National Highway Traffic Safety Administration

49 CFR Parts 564 and 571

Replaceable Light Source Information Federal Motor Vehicle Safety Standards; Lamps, Reflective Devices and Associated Equipment

AGENCY: National Highway Traffic Safety Administration (NHTSA), DOT.
ACTION: Notice of proposed rulemaking.

FIGURE 8 - BULB DEFLECTION TEST

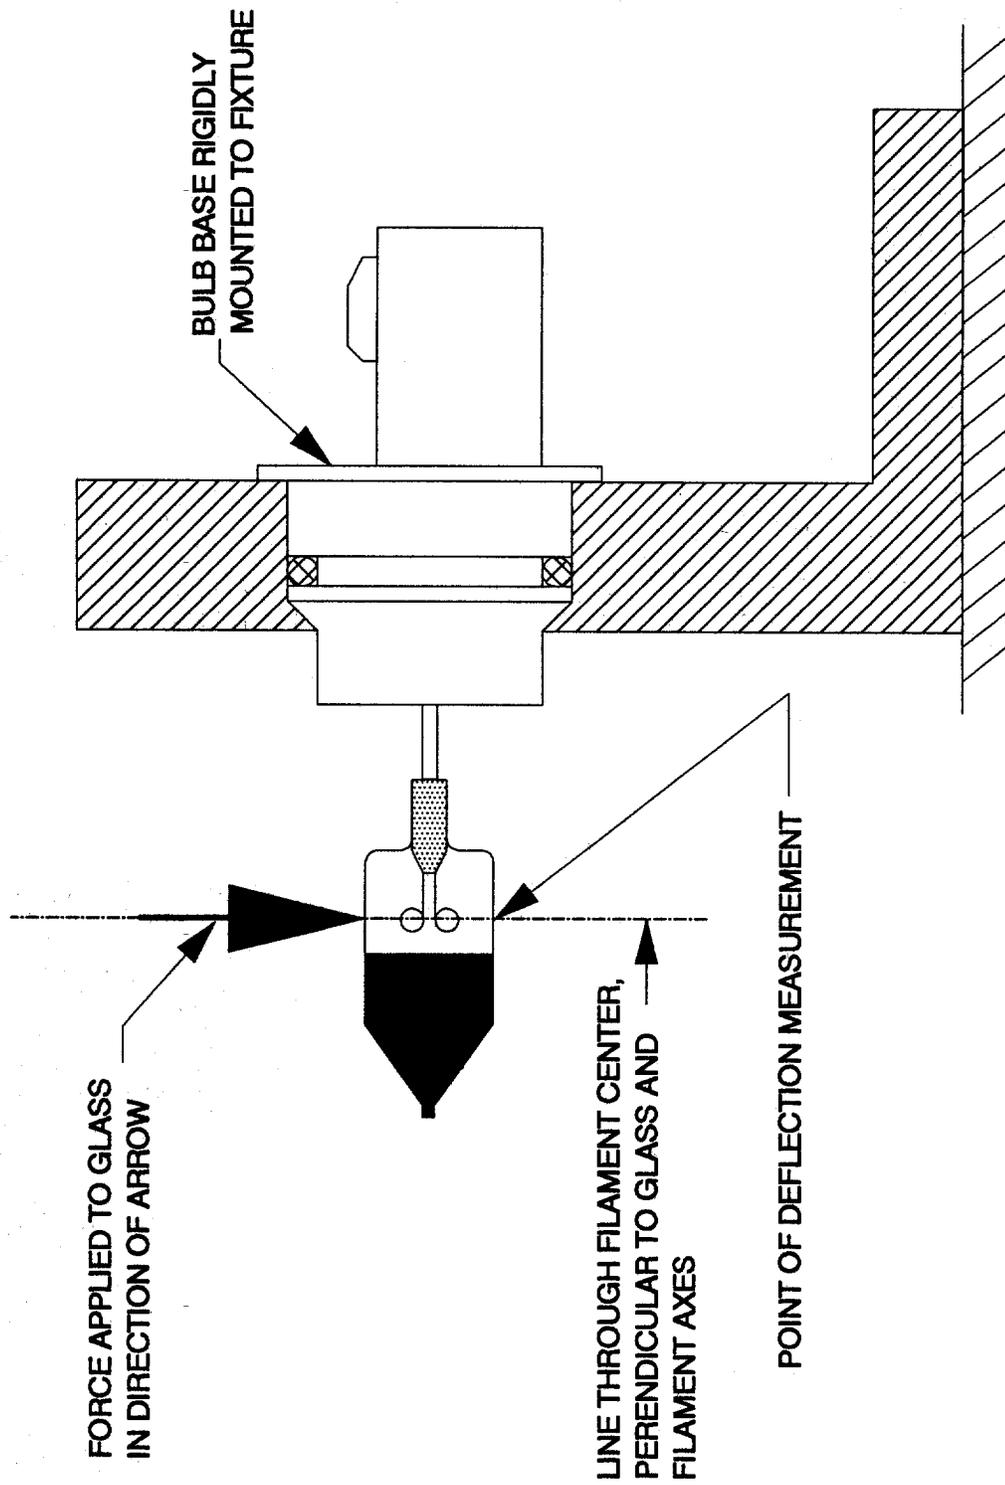
- a. revising the definition of "Replaceable Light Source" in section S4 to read as set forth below;
- b. revising paragraph S7.7 to read as set forth below;
- c. revising the last sentence of S9 as set forth below; and
- d. removing and reserving Figures 3-1 through 3-11, 19, 19-1 through 19-5, 20, 20-1 through 20-5, 23-1 through 23-7, and 24-1 through 24-9.
- e. revising Figures 8 and 25 as set forth below.

S9 *Deflection test for replaceable light sources.* * * * Distance 'A' for a replaceable light source other than an HB Type shall be the dimension provided in accordance with Appendix A of part 564 of this chapter, section I.A.1 if the light source has a lower beam filament, or as specified in section I.B.1 if the light source has only an upper beam filament.

FIGURE 25 - PRESSURE CHAMBER

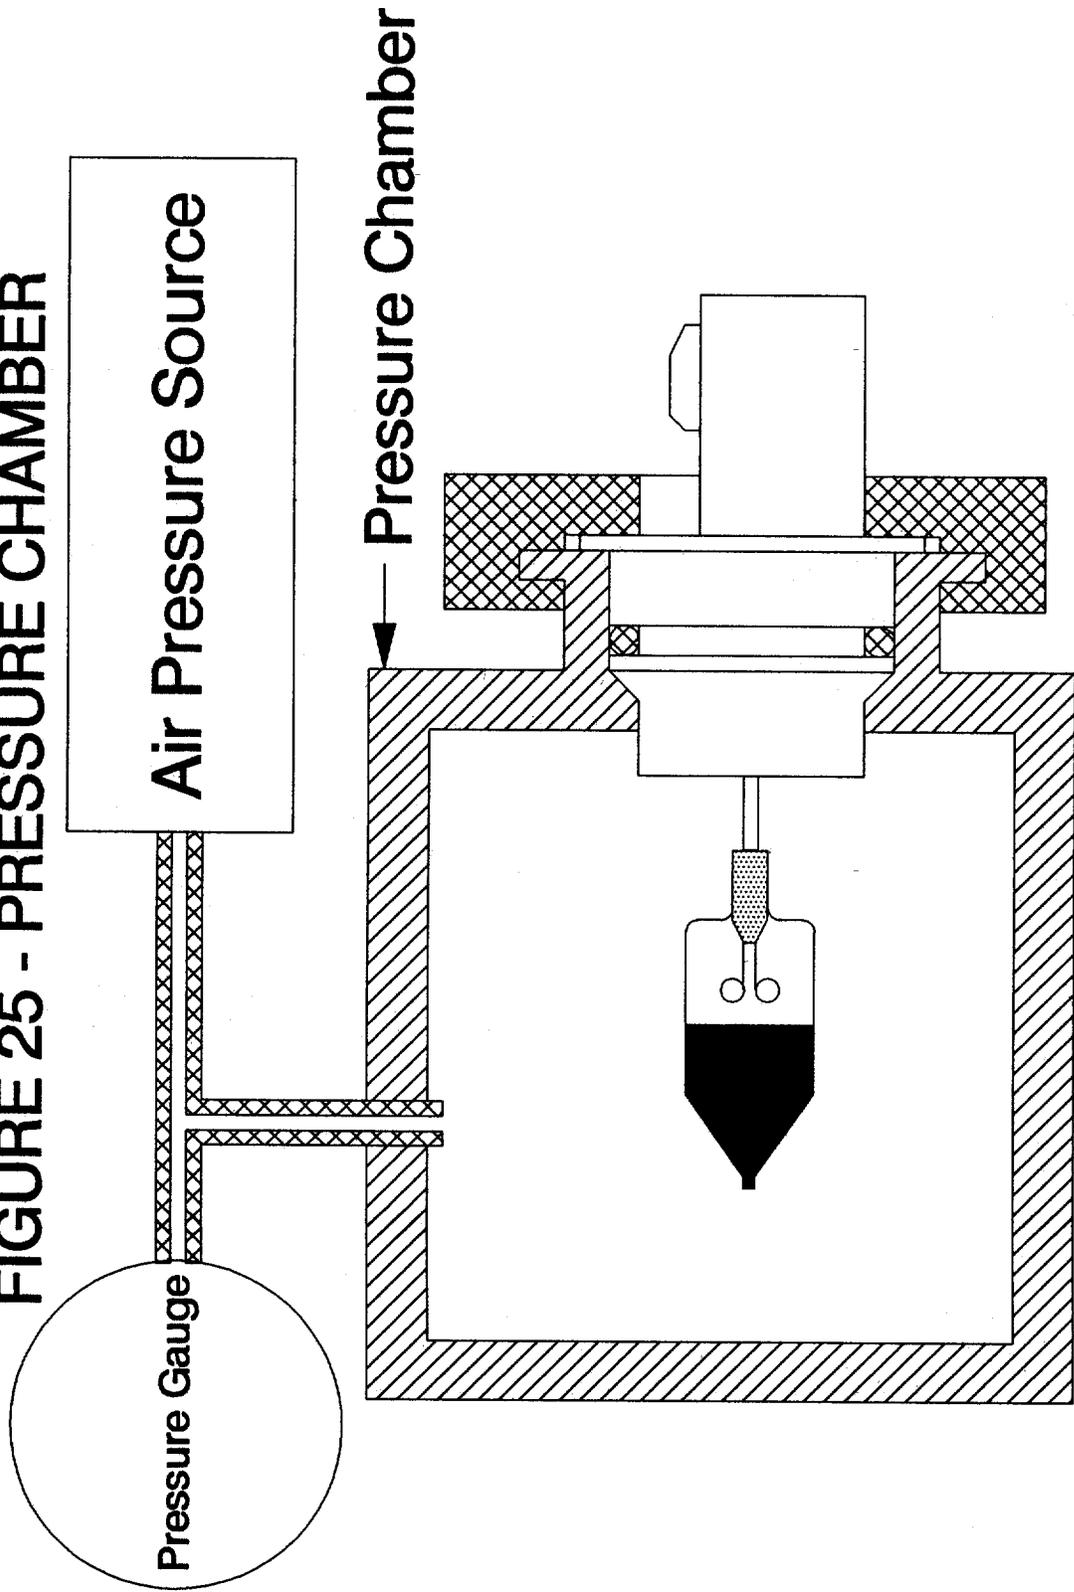
(c) The capsule, lead wires and/or terminals, and seal on each Type HB1, Type HB3, Type HB4, and Type HB5 light source, and on any other replaceable light source which uses a seal, shall be installed in a pressure chamber as shown in Figure 25 so as to provide an airtight seal. The diameter of the aperture in Figure 25 on a replaceable light source (other than an HB Type) shall be that figure furnished for such light source in compliance with Section IV.B of Appendix A of part 564 of this chapter. An airtight seal exists

when no air bubbles appear on the low pressure (connector) side after the light source has been immersed in water for one minute while inserted in a cylindrical aperture specified for the light source, and subjected to an air pressure of 70kPa (10 P.S.I.G.) on the glass capsule side.

Aperture in pressure chamber for bulb made to dimensions listed for aperture for bulb in response to Part 564.5(a).
